Well Name: JRU APACHE U FEDERAL Well Location: T22S / R30E / SEC 24 /

Well Number: 708H Type of Well: OIL WELL Allottee or Tribe Name:

Type of Submission: Notice of Intent Type of Action: APD Change

Procedure Description: JRU APACHE U FEDERAL COM 708H APD ID# 10400081579 SUNDRY LANGUAGE XTO Permian Operating, LLC. respectfully requests approval to make the following changes to the approved APD. Changes to include SHL, KOP, FTP, LTP, BHL, casing design, cement program, mud circulation system and proposed total depth. FROM: TO: SHL: 381' FNL & 1029' FEL OF SECTION 24-T22S-R30E 380' FNL & 949' FEL OF SECTION 24-T22S-R30E KOP: 381' FNL & 1029' FEL OF SECTION 24-T22S-R30E 610' FNL & 330' FEL OF SECTION 24-T22S-R30E FTP: 330' FSL & 330' FEL OF SECTION 13-T22S-R30E 610' FNL & 330' FEL OF SECTION 24-T22S-R30E LTP: 330' FSL & 2540' FEL OF SECTION 14-T22S-R30E 610' FNL & 2579' FEL OF SECTION 23-T22S-R30E BHL: 330' FSL & 2590' FEL OF SECTION 14-T22S-R30E 610' FNL & 2629' FEL OF SECTION 23-T22S-R30E The proposed total depth is changing from 17703' MD/9532' TVD to 17185.75' MD/9809' TVD There are no changes requested to the facilities/surface usage that was approved along with the APD. See a

Figure B - 3 String Design - Open Production Casing Annulus (Updated May 2024):

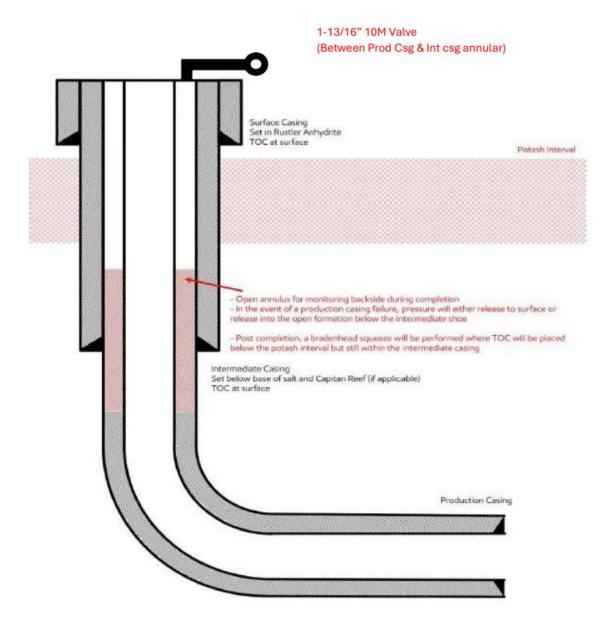
XTO is aware of the R-111-Q update & will comply with these requirements including (but not limited to):

- 1. Alignment with KPLA requirements per schematic above, leaving open annulus for pressure monitoring during frac and utilizing new casing that meets API standards
- 2. Contingency plans in place to divert formation fluids away from salt interval in event of production casing failure
- 3. TOC in the annulus between intermediate & production casing string shall stand uncemented at least 500 feet below the intermediate casing shoe
- 4. Bradenhead squeeze to be completed within 180 days after hydraulic frac operations have been concluded to ensure at least a 500 feet tie-back has been established inside salt string but with top below MB 126
